HISTORIC AND DESIGN REVIEW COMMISSION

August 19, 2020

HDRC CASE NO: 2020-242
ADDRESS: 326 RIVERSIDE DR
LEGAL DESCRIPTION: NCB 7672 BLK 21 LOT NW 170 X 15 OF 5, N IRR 190 OF 6, N 207.86 OF 7, N 207.86 OF E 102 OF 8
ZONING: C-2, RIO-5
CITY COUNCIL DIST.: 3
DISTRICT: Mission Historic District
APPLICANT: Patrick Christensen
OWNER: 326 RIVERSIDE LLC
TYPE OF WORK: Demolition with new construction
APPLICATION RECEIVED: June 03, 2020
60-DAY REVIEW: Not applicable due to City Council Emergency Orders
REQUEST:

The applicant is requesting conceptual approval to:

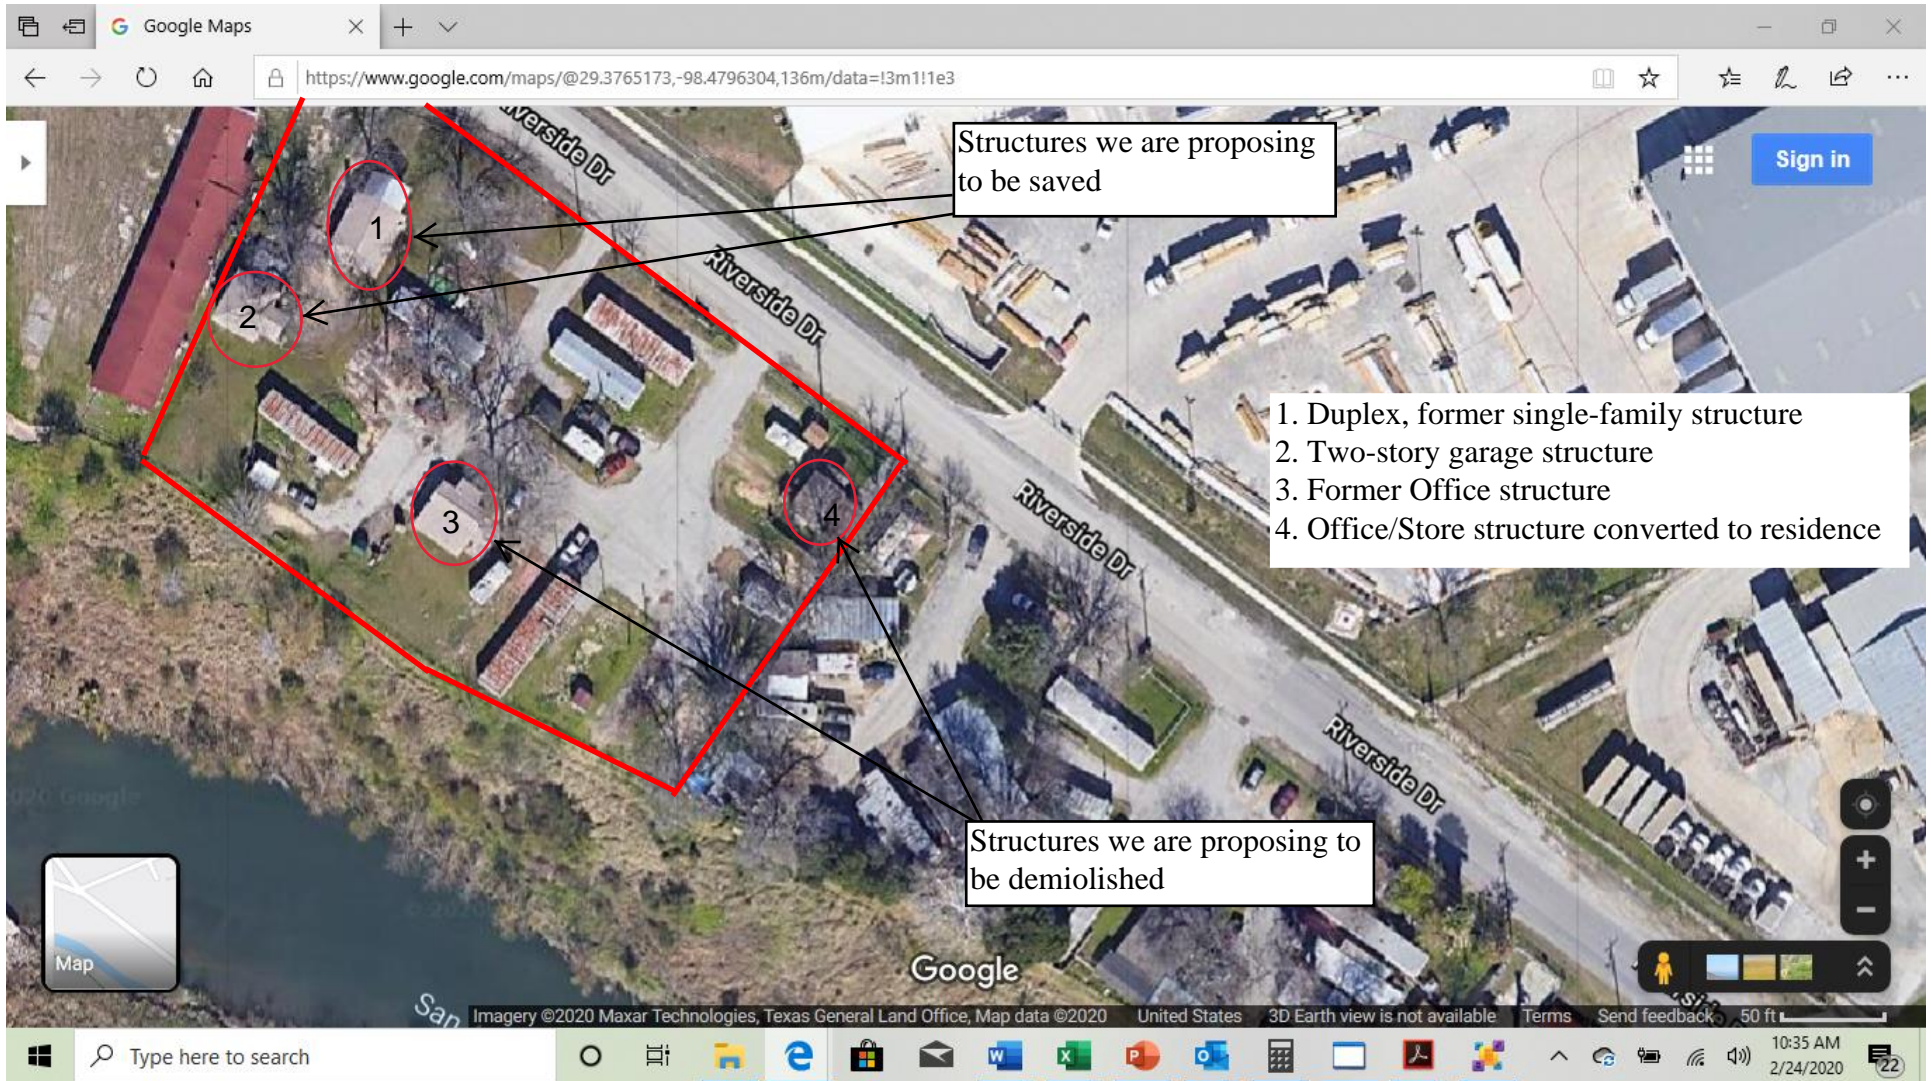
SC: Structure 4 does not appear to be a good candidate for reuse, per physical condition.

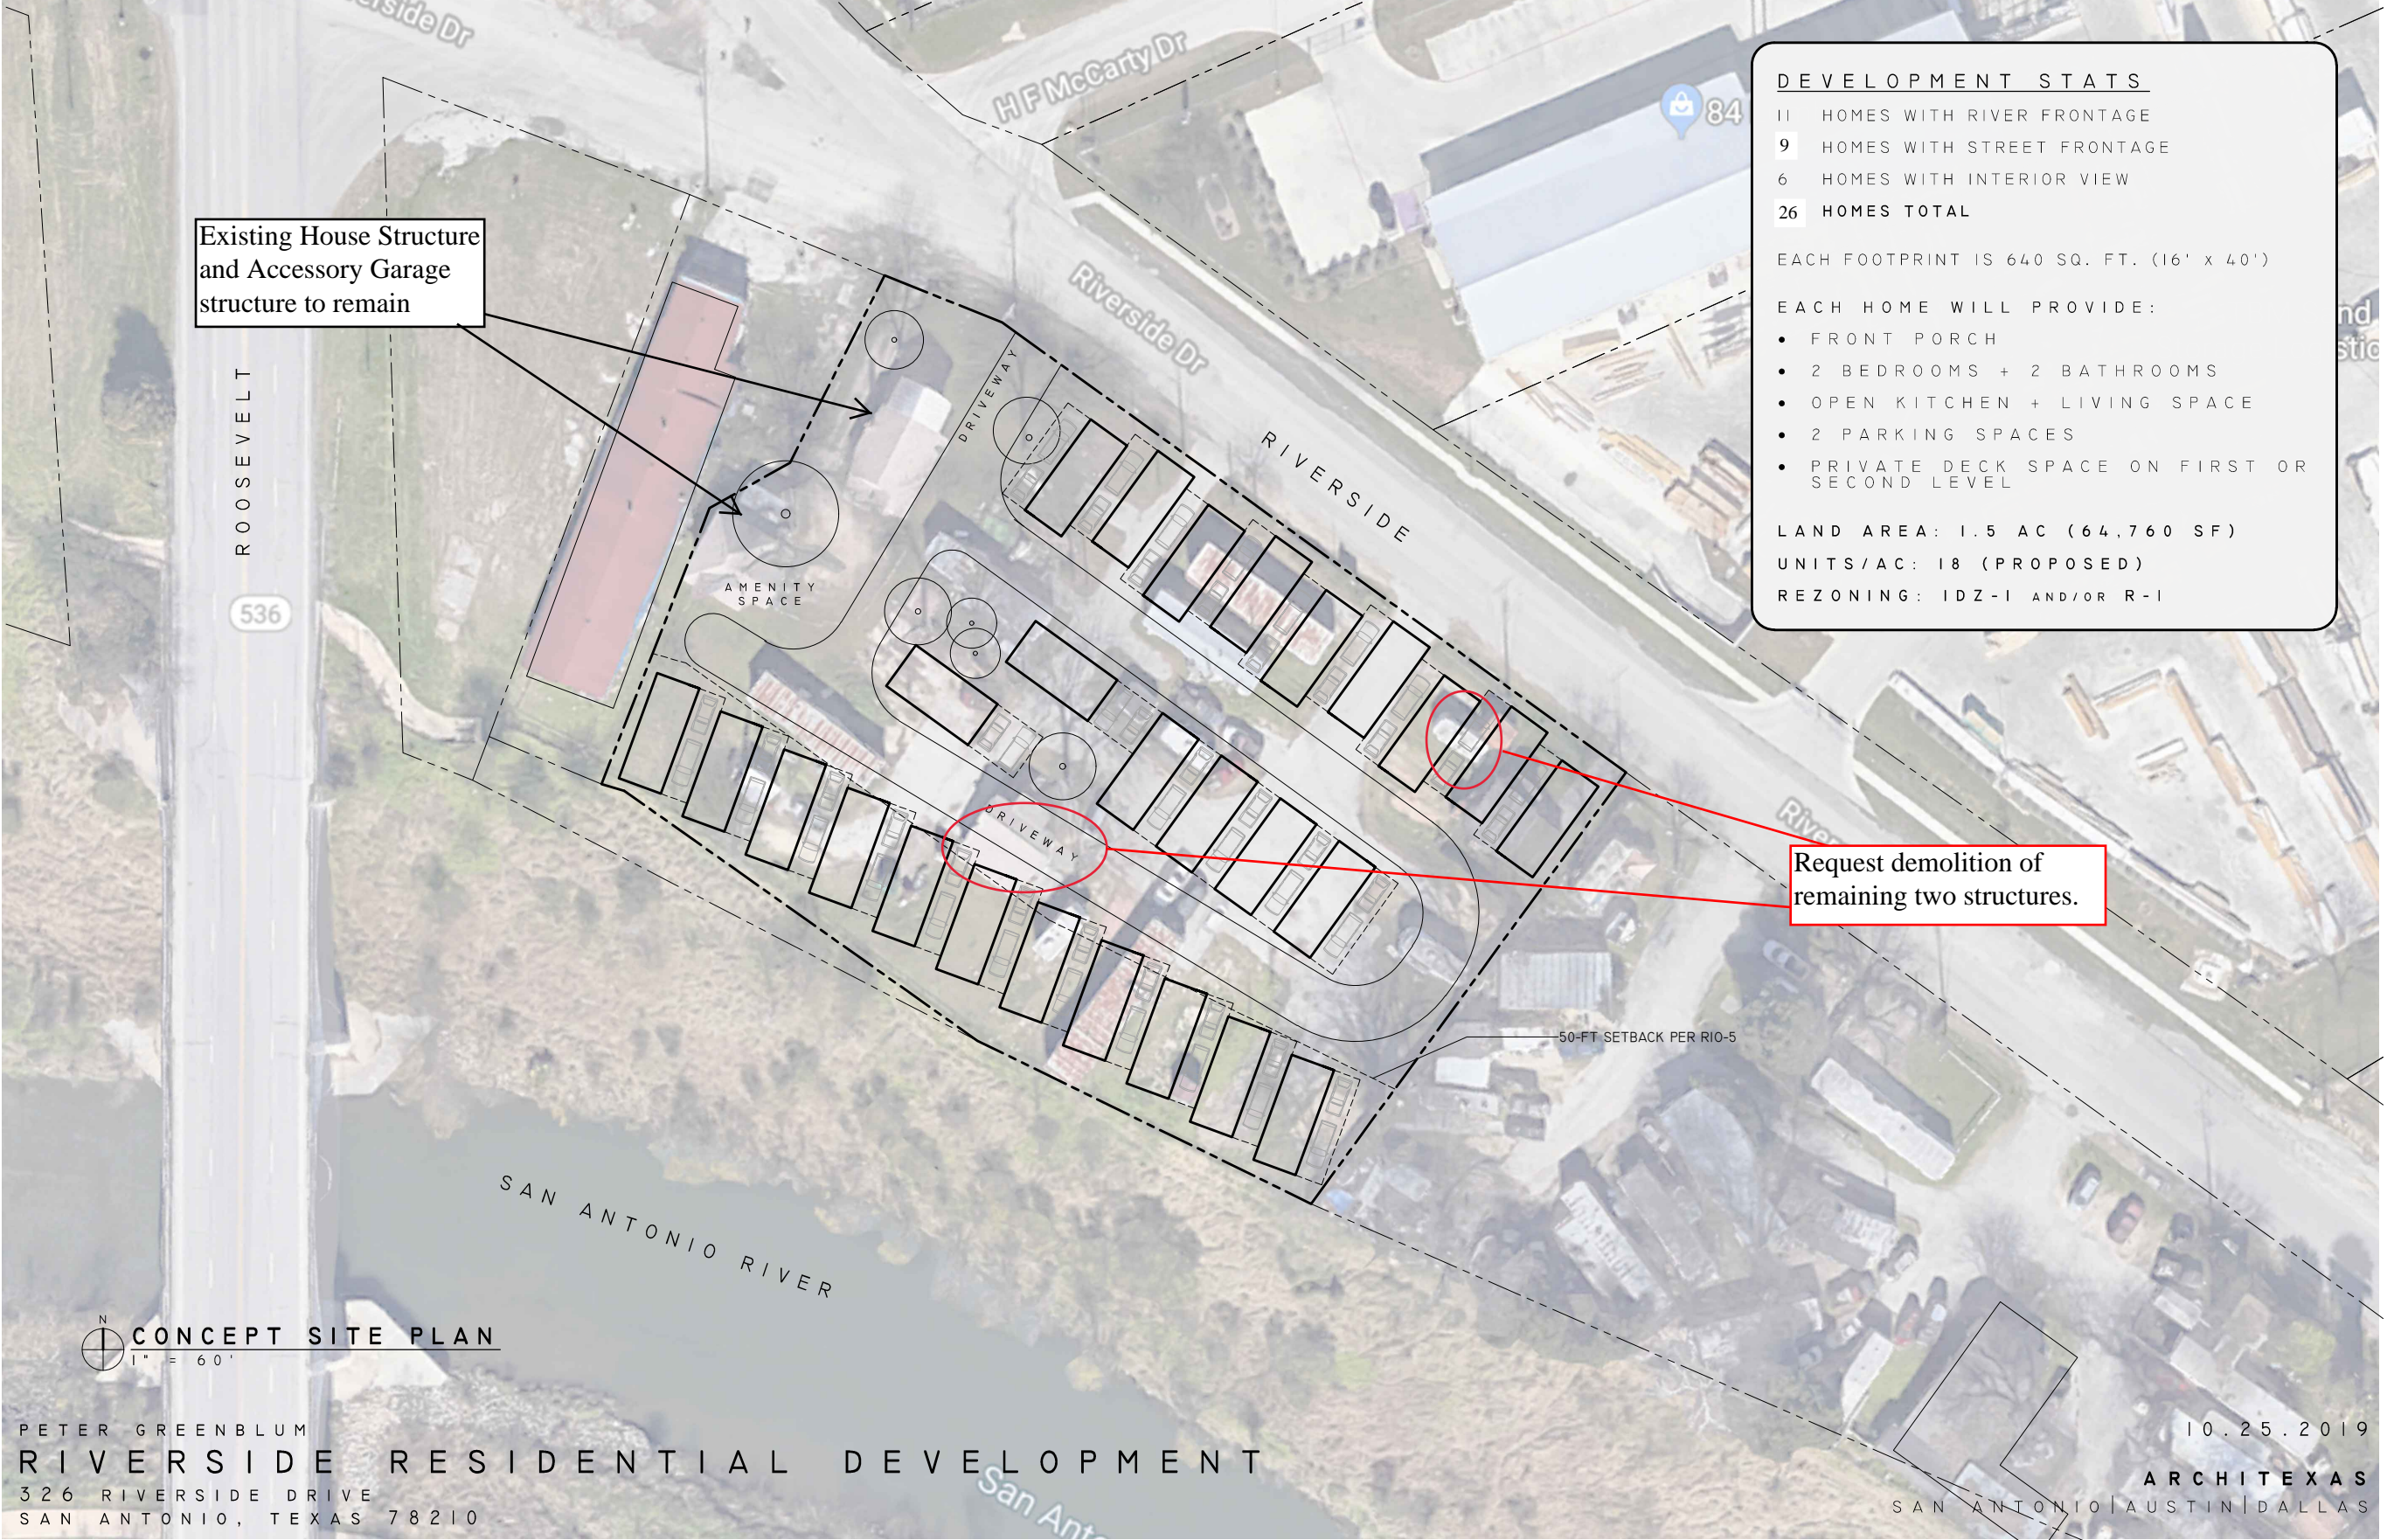
SC: The replacement plan appears to be a bit challenging.
